ADDENDUM 5
To Contract Documents for
EYECARE MEDICAL GROUP
53 SEWALL STREET
PORTLAND, ME 04102

E.M.G. - Phase 2 Addition & Renovation

EYECARE MEDICAL GROUP
PHASE 2 ADDITION AND RENOVATION
ADDENDUM NO. 5
August 9, 2013

SHEET
SKE-06

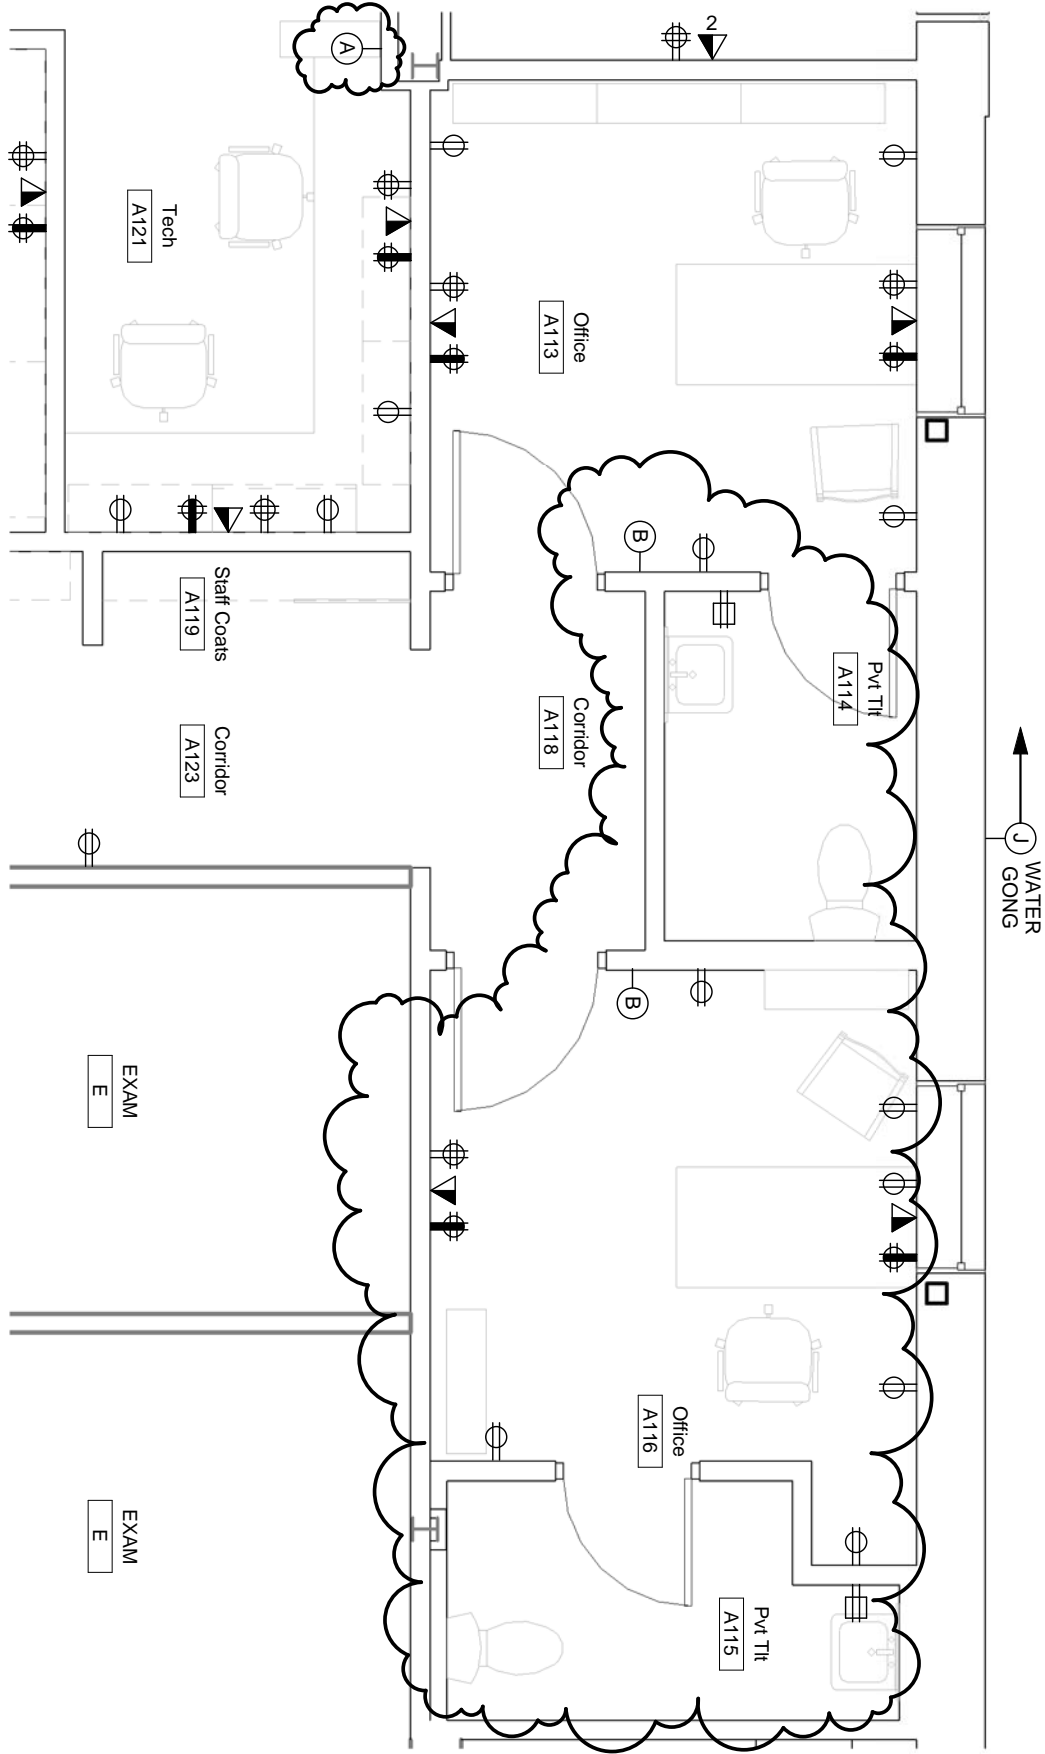
2. Sheet ELI00: Refer to attached Sketches SKE-09 and SKE-10 for revisions.
3. Sheet EPI00: Refer to attached sketches SKE-06 and SKE-07 for revisions.
4. Sheet EPI01: At Post Op BI09, **DELETE** the six wall mounted telephone outlets added under Addendum N03.

SHEET
SKE-08

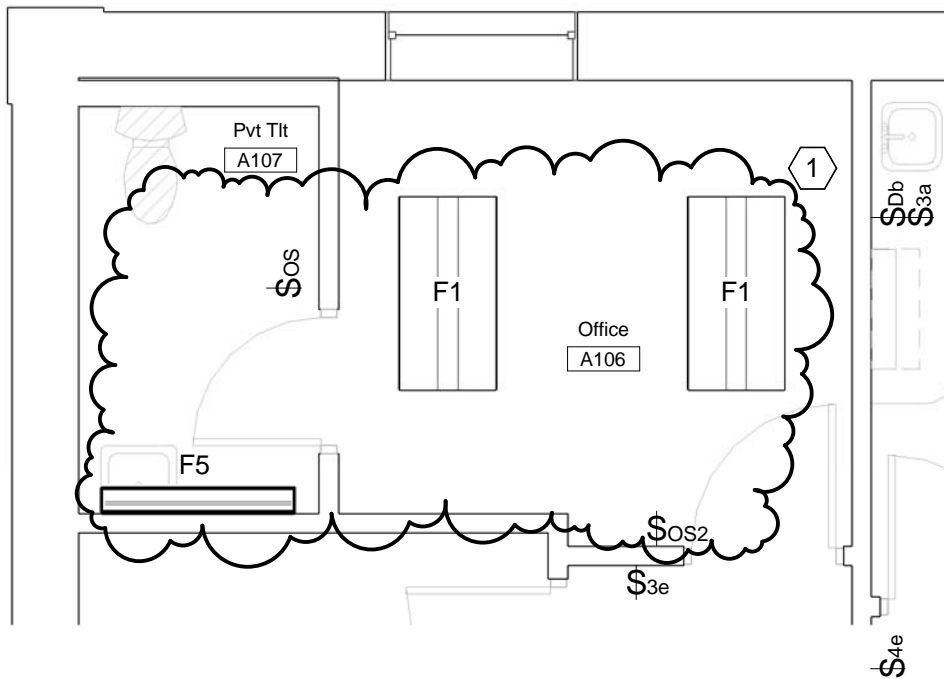
7. Sheet EPI02: Clarification: The chiller to be relocated is fed from a 90-amp, 3-pole circuit breaker in existing Panel DP.
8. Sheet EPI02: In lieu of indicated locations for RTU-1, EF-4, and EF-5, the units shall be located as indicated on attached Sketch SKE-08.

SHEET	SKE-11
-------	--------

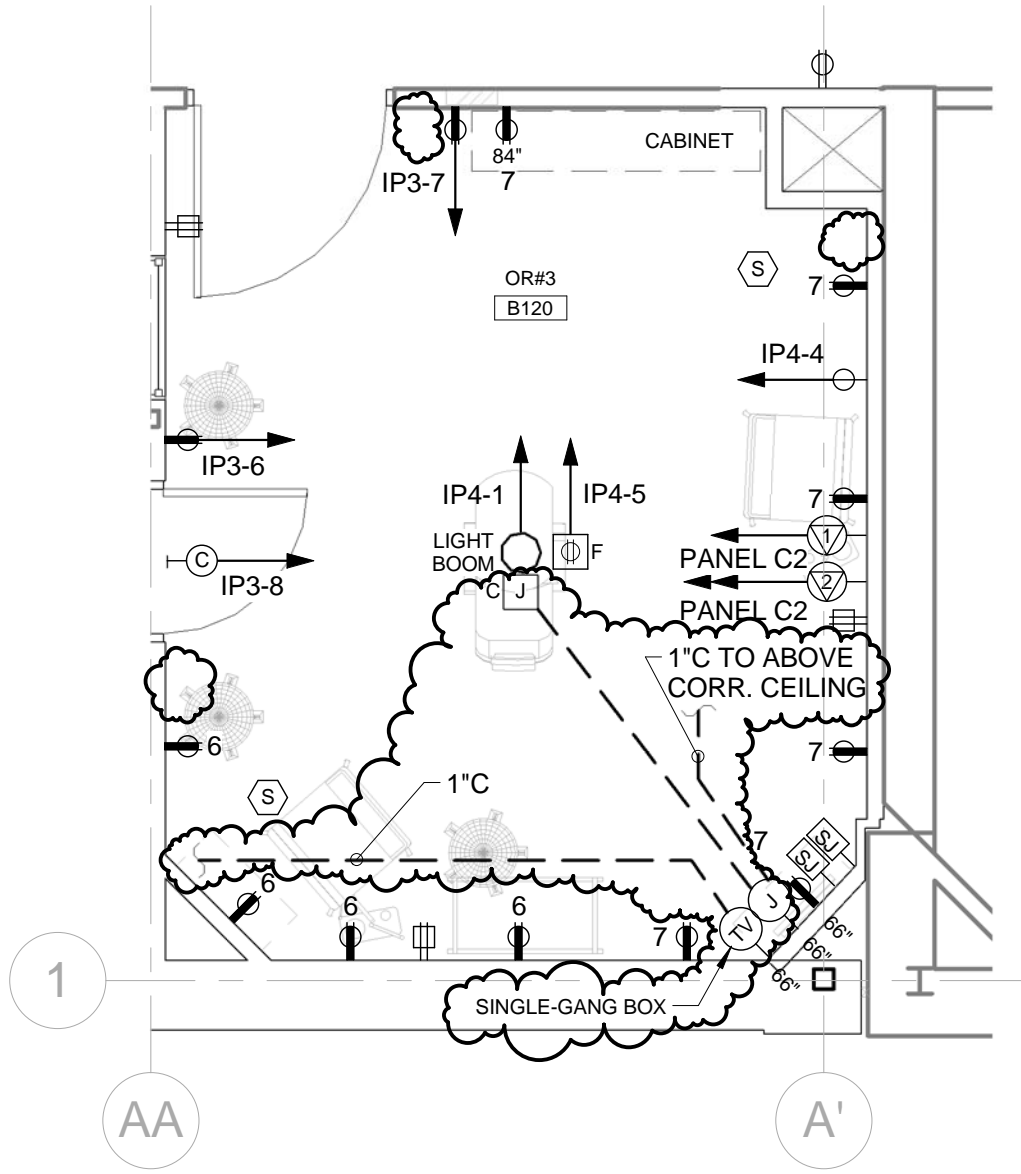
5. Sheet EPI01: At Nurse BI23, **DELETE** the indicated receptacles and tel/data outlets. Existing items in this room shall remain.
6. Sheet EPI01: Refer to attached sketches SKE-11, SKE-12, and SKE-13 for further revisions.
